Agenda Item # 8

SUB-002792-2023 & MOD-002804-2024

Resubdivision of Lot 1 of the Resubdivision of Lot 2 of Bel Air Mall Subdivision

Proposal:

SITE PLAN

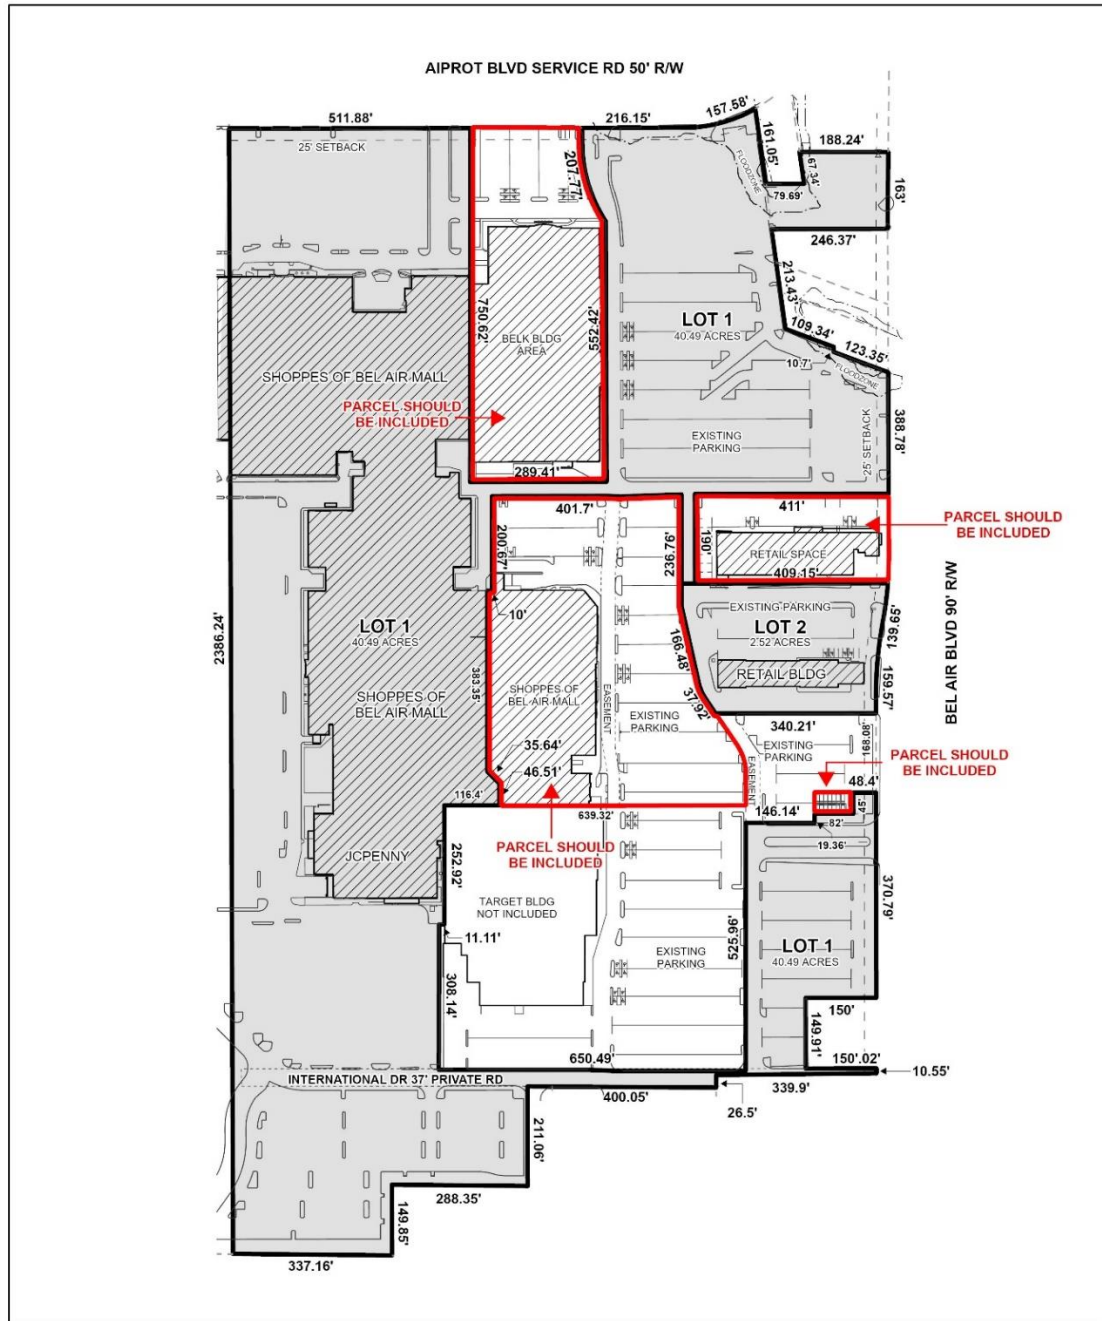
It should be noted that the PUD site plan correctly labels existing lots adjacent to the subject site, but does not clearly indicate that they are not a part of the subject Subdivision application. If approved, the Final Plat should be revised to clearly label adjacent lots and their associated Subdivision names as well as the associated map book and page or instrument number.

Additionally, the 2021 PUD included Lots 2 and 3, Resubdivision of Lot 2, Bel Air Mall Subdivision, and a condition of approval for that PUD was "inclusion of Lots 3 and 4, Bel Air Mall Subdivision". As submitted, the site plan states that only Lot 1, Resubdivision of Lot 2, Bel Air Mall Subdivision is included. As such, the application should be heldover so that the applicant can revise the site plan to include the required parcels highlighted in red on the images on pages 2 and 10 in this report. The inclusion of these additional parcels will not result in any additional notifications being required. However, the consent of the owners of those parcels will be required.

It should be noted that future development or redevelopment of the proposed lots may require additional modifications of the PUD to be approved by the Planning Commission and City Council. A note stating as much should be placed on the recorded site plan, if approved.

- 1) Revision of the site plan to include Lots 3 and 4, Bel Air Mall Subdivision as required by the 2021 PUD
- 2) Submittal of authorization of the property owners for Lots 2 and 3, Resubdivision of Lot 2, Bel Air Mall Subdivision and Lots 3 and 4, Bel Air Mall Subdivision; and
- 3) Revision of the site plan to clearly label adjacent lots and their associated Subdivision names as well as map book and page or instrument number.
